# City of West Allis

### Plan Commission

Wednesday, October 25, 2023

**STAFF REPORT  
WEST ALLIS PLAN COMMISSION  
Wednesday, October 25, 2023  
6:00 PM**

EXTERIOR ELEVATIONS  
**A4.00**

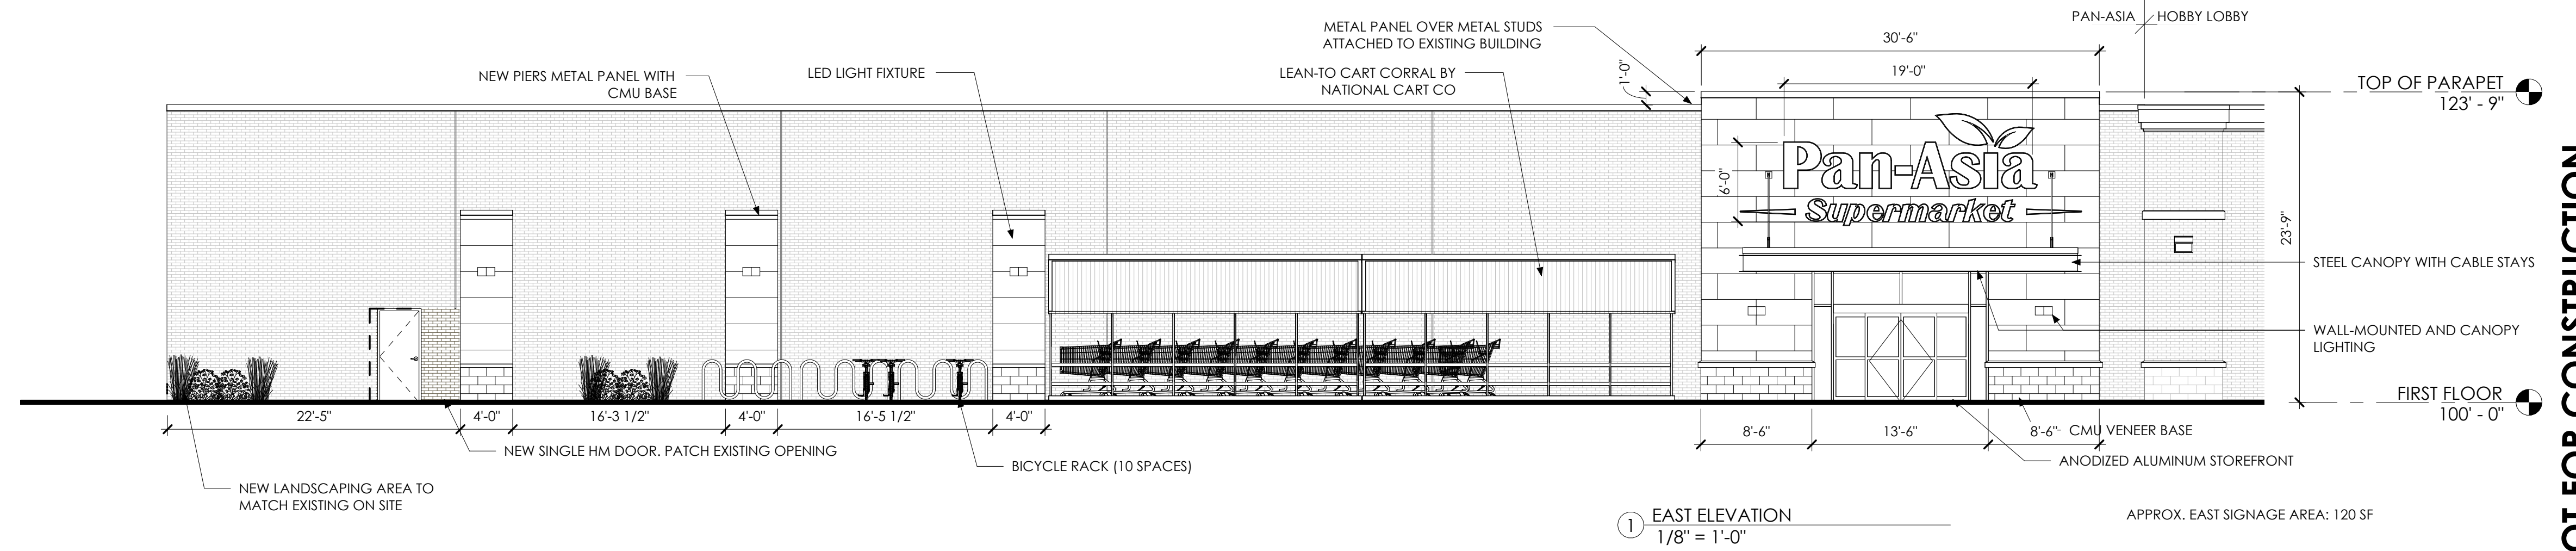
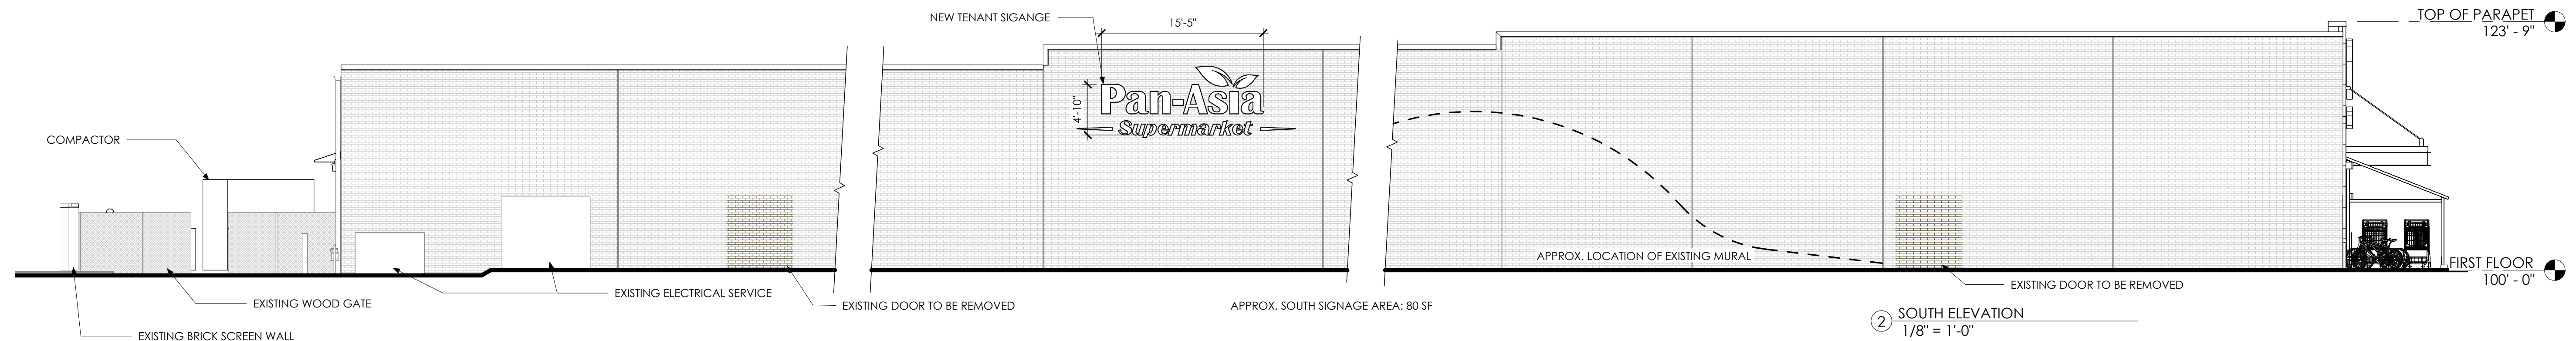
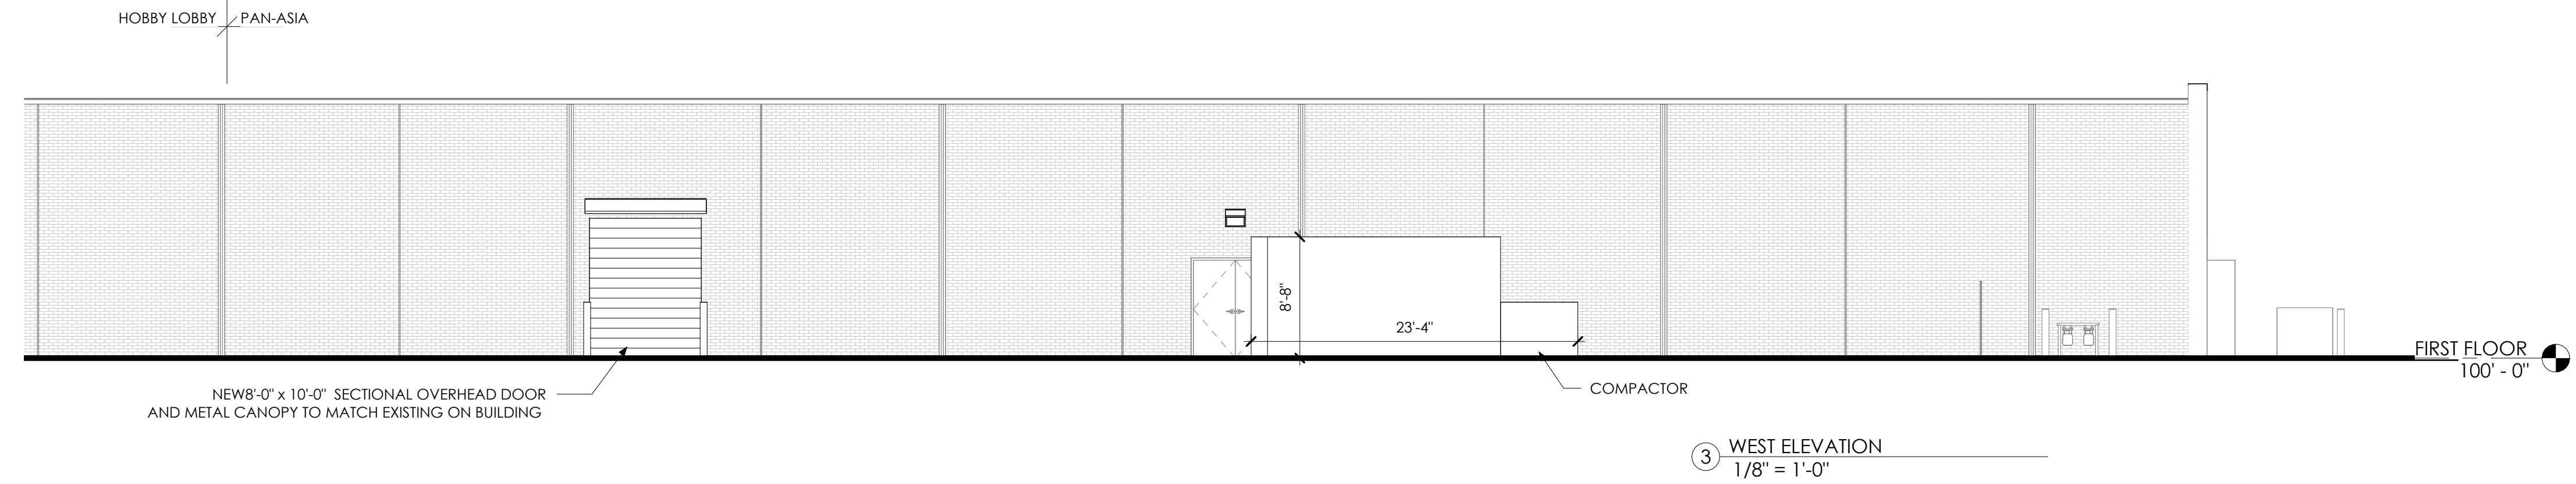
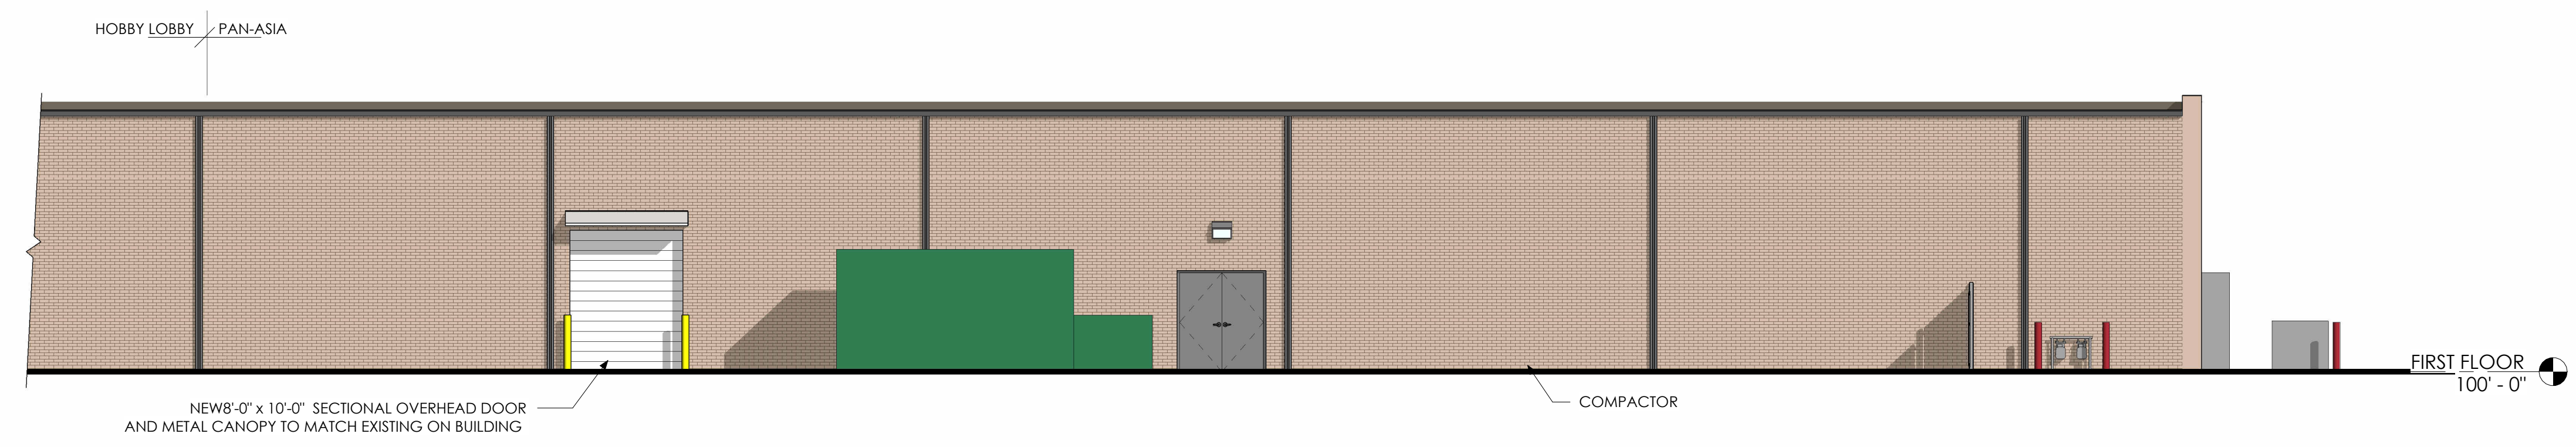
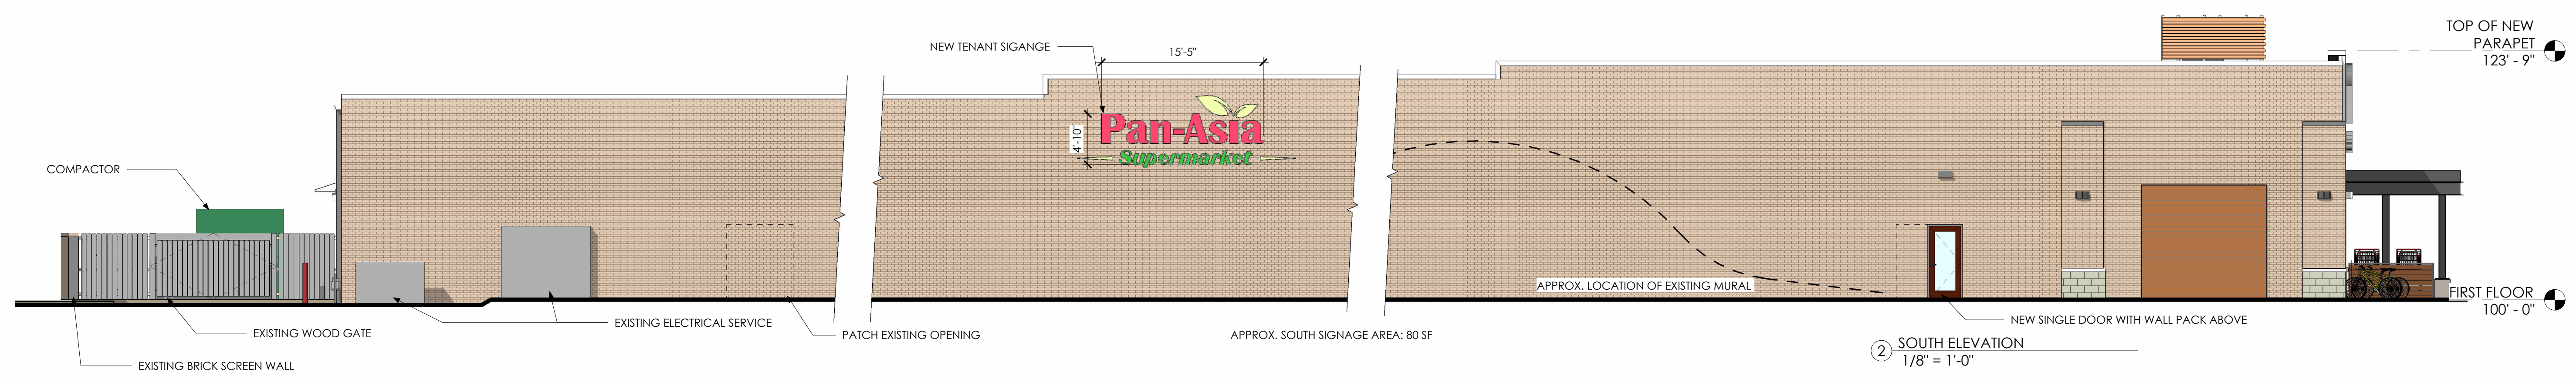
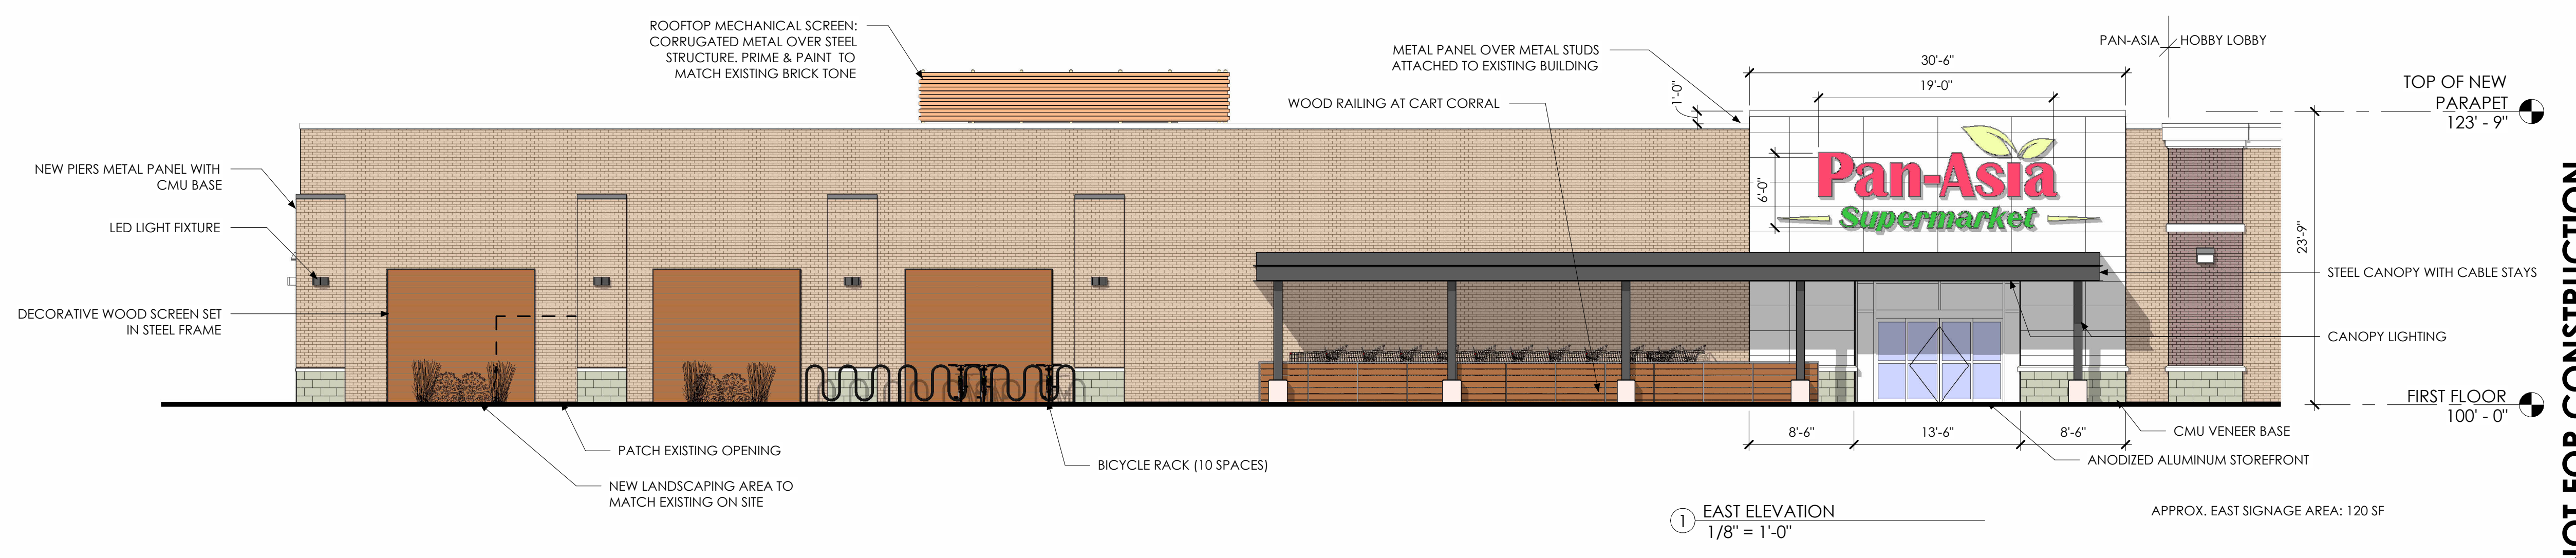
The numbered items below are staff comments shared with the applicant upon review of the original plan submittal. The applicant's design team has revised plans to accommodate staff's recommendations. A comparison of the initial and most recent plan submittals is provided for Plan Commission review. After reviewing the revised plans, items 1-3 are satisfied, and items 4-5 were offered to applicant for consideration but not required.

2. There is a large pilaster just north of the Pan-Asia entry (at south end of Hobby Lobby space). Thoughts on adding a similar proportioned feature on SE corner of building except with Pan-Asia cladding.
3. General questions on where and how visible any exterior HVAC rooftop units (existing/new) and considerations on how kitchen area will be vented (wall or rooftop). Is there a plan sheet that will show these features?
4. Placement of the kitchen on the east wall versus placing some seating and windows on east wall. If flipped/re-orientated then windows could be incorporated into the east wall design (benefits like natural light, storefront attraction, visibility).
5. The new storefront entry into the building looks great. Curious on the location of the entry toward the north side of the tenant space? Floor planning customer flow a likely reason, but just asking.

1. Submit revised site, landscaping, and architectural plans to the Planning & Zoning office to show the following: a) a detail of the proposed exterior wood screens in steel frames on the facade; b) rooftop plan and screening material details; (c) cart corral details; (d) curb extension added along storefront pedestrian walkway.
2. A driveway permit being applied for with City Engineering Department for work within the City Right-of-Way.
3. Signage plans being submitted for sign permit review.
